Subject: Project No. 704 – Draft NRC Safety Evaluation of BWRVIP-138, Revision 1

BWRVIP 2012-058

1  
2  
3 DRAFT SAFETY EVALUATION BY THE OFFICE OF NUCLEAR REACTOR REGULATION  
4 FOR TECHNICAL REPORT TR-1016574, "BWRVIP-138, REVISION 1 BOILING WATER  
5 REACTOR VESSEL AND INTERNALS PROJECT,  
6 "UPDATED JET PUMP BEAM INSPECTION AND FLAW EVALUATION GUIDELINES"  
7 (TAC NO. ME2191)

Figure 1. CGR in NWC environment vs. applied K trends from different sources.

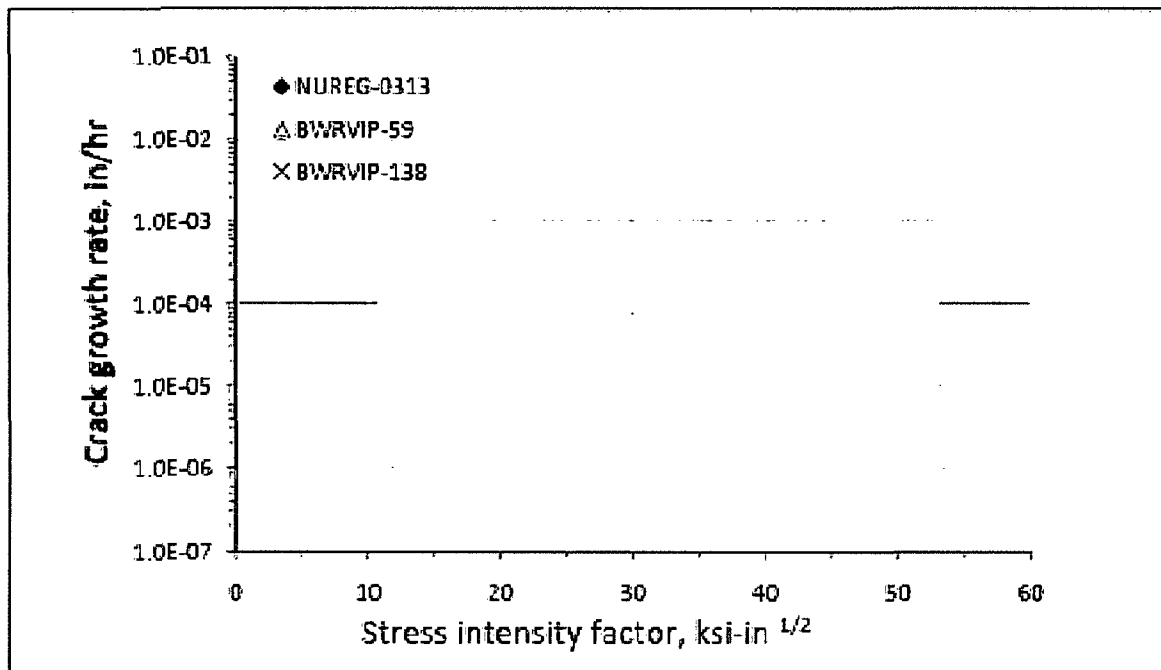
25 The staff has summarized in Figure 1 the CGRs for NWC from two other sources to compare  
26 with the assumed crack growth trends with those found in this submittal. The trend proposed in  
27 the submittal for Alloy X-750 has a lower absolute value than that which is used as an upper  
28 bound for sensitized pipe welds made from austenitic stainless steels (Reference 4); the trend  
29 for Alloy X-750 is equal to (at applied K ) or higher than (at applied K )  
30 that used for Alloy 600 and 182 welds in BWR internals (Reference 5). Given the BWRVIP  
31 response to RAI 7 and the information in Figure 1, the staff concludes that the proposed CGR  
32 curve for Alloy X-750 in the NWC environment may not represent an absolute upper-bound to  
33 the CGR, but does provide for a reasonable extrapolation to lower applied K values and, at this  
34 point in time, is acceptable to use in the LEFM calculations. If the results of the supplemental

35 CGR testing on a representative heat of Alloy X-750 that the BWRVIP is currently conducting do  
36 not confirm the assumed X-750 CGRs, then the BWRVIP should re-evaluate the proposed re-  
37 inspection intervals using the results of the supplemental testing. This resolves the issues in TS  
38 RAI 7.  
39

20 As discussed in Section 3.2 of this SE, the staff requests that the BWRVIP reassess the  
21 proposed CGR curve for the applied K range of . If the results of the supplemental TS  
22 CGR testing on a representative heat of Alloy X-750 that the BWRVIP is currently conducting  
23 are not bound by the assumed X-750 CGRs, then the BWRVIP should re-evaluate the proposed  
24 re-inspection intervals using the results of the supplemental testing.  
25
